Engineering Change Notification

NHD-240128WG-ATFH-VZ#
NHD-240128WG-ATFH-VZ#-C
NHD-240128WG-ATFH-VZ#-H
NHD-240128WG-ATMI-VZ#

Old Design	New Design

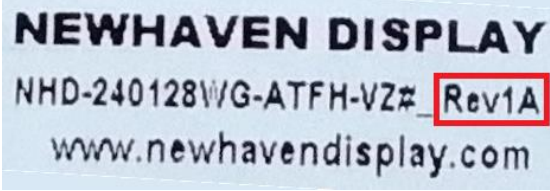
The PCB, glass, bezel and backlight used in the manufacturing of these displays have been redesigned to improve quality performance and long-term manufacturing sustainability.

- PCB: Component layout changed. No change to connector pinout or position.
- Glass: Liquid crystal changed. No change to active area or viewing area.
- Bezel: Mechanical structure changed. No change to overall LxWxH dimensions.
- Backlight: LED components changed. Can work with higher input supply current.

The new display will be labeled with a different revision control number after the part number. See example below.
